SUBJECT: ADDENDUM # 1

PROJECT TITLE: Renovation To Hamden DMV
1985 State Street
Hamden, Connecticut

PROJECT NO.: **BI-MM-041**

BID OPENING	**1:00 P.M.**	**February 10, 2010**
ADDENDUM NUMBER 1	**DATE OF ADDENDUM**	**February 1, 2010**

DRAWING NO:
SK-A1
ADDENDUM # 1
DATE: JAN 29, 10
SCALE: 3"=1'-0"

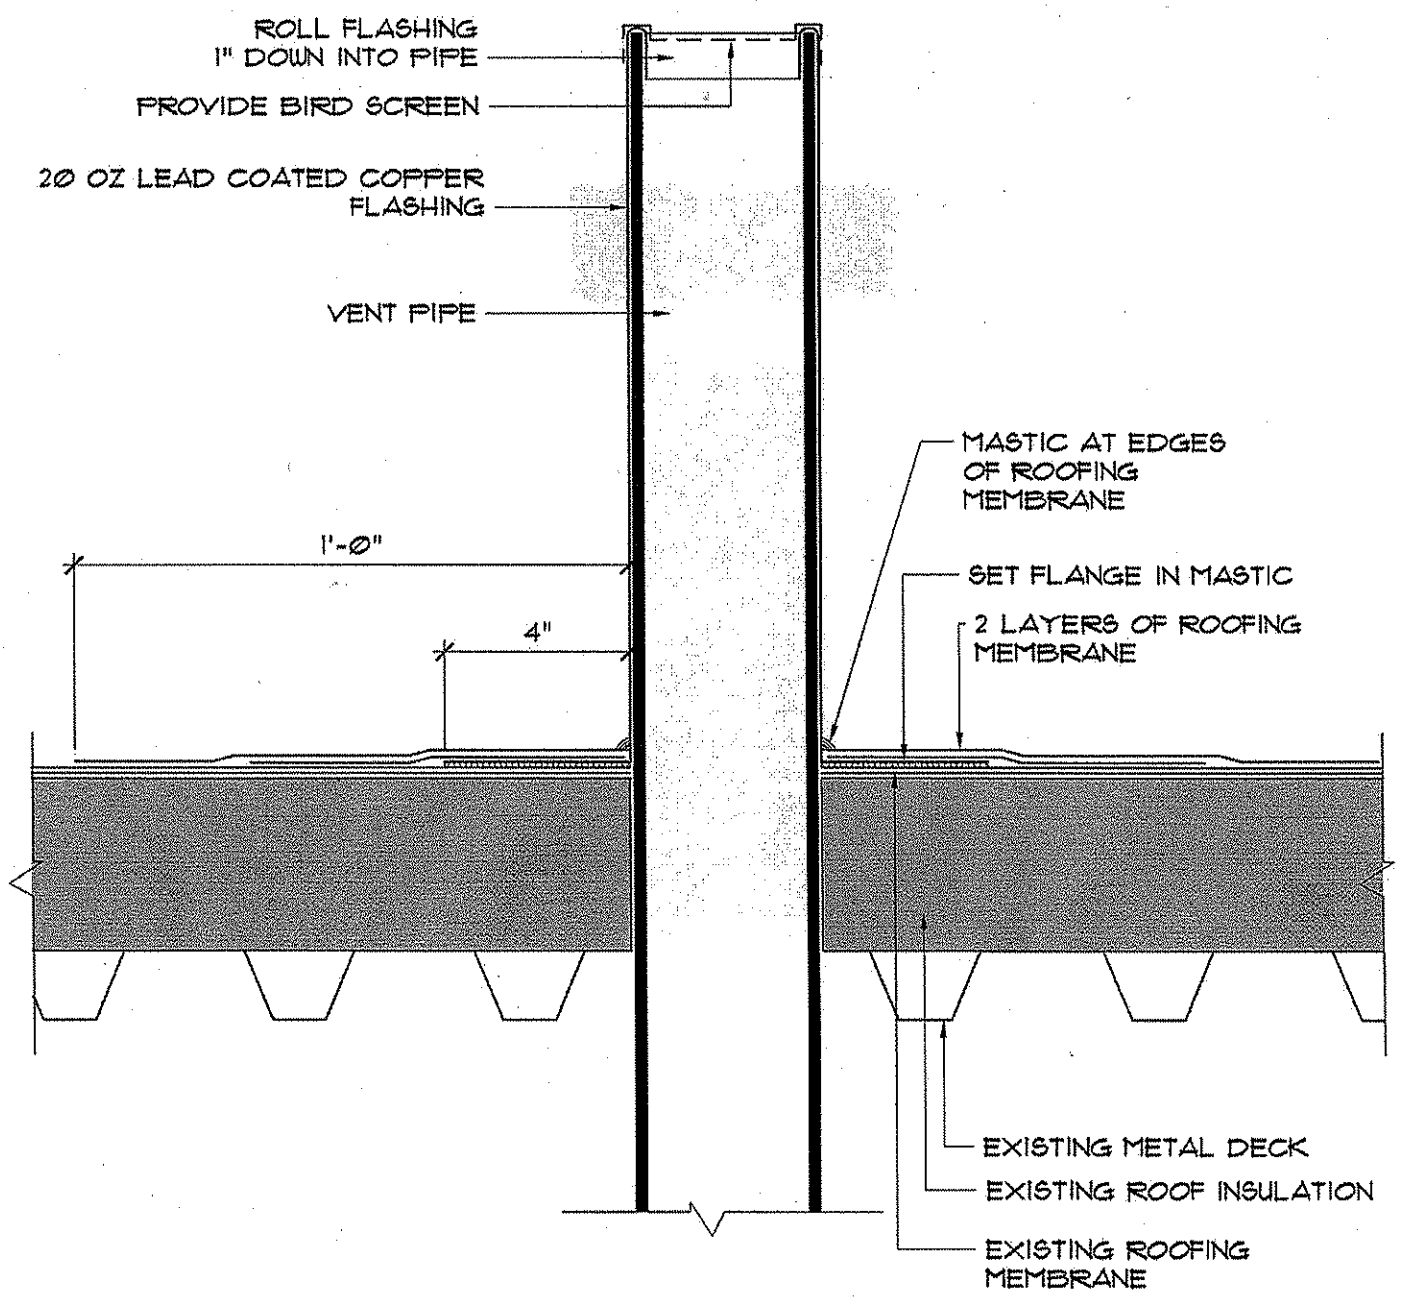
18- Drawing P-1 and P-1A
Add note:
"4"SE VTR and 4" VTR are to rise up to the roof as tight against the existing wall of Stair S02 as possible. Core drill existing second floor concrete slab for the vent pipes. Space cores 12" apart to avoid requiring structural support. Fire sealant opening around pipes with UL designed 1 hour system. Cut opening in existing roof deck and roofing system for new vent pipes. Cut opening as small as possible to avoid requiring structural support. Provide flashing detail as shown on SK-A1, SKP-01 and SKP-01A attached."

6 / P-3

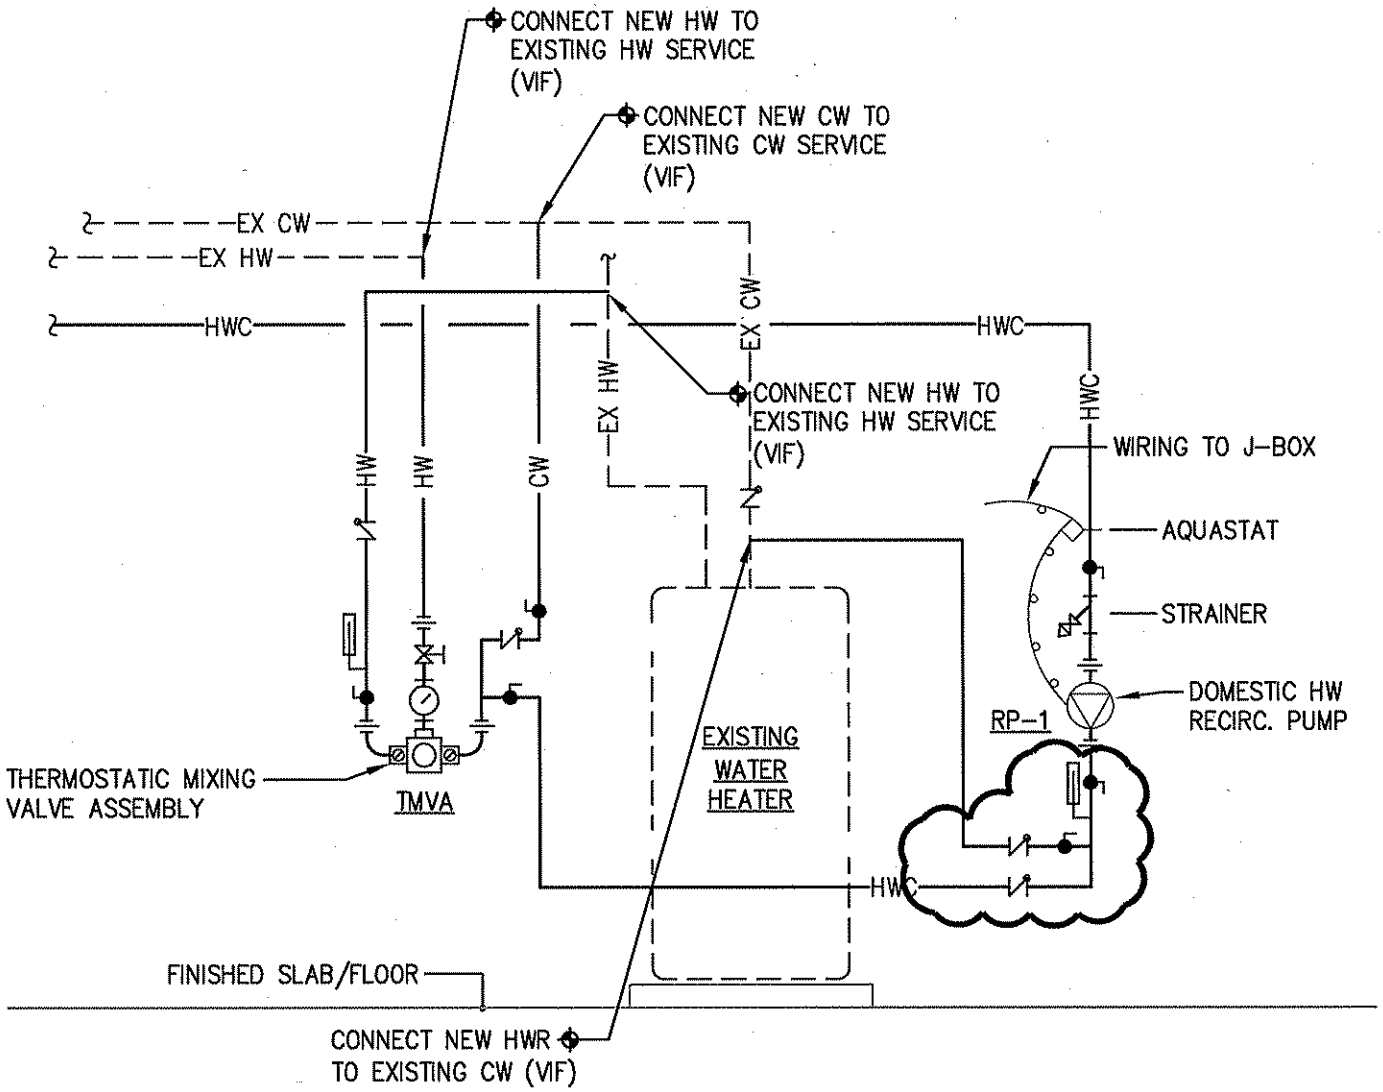
19- Drawing P-3
Detail 6/P-3: see revisions on
SKP-02
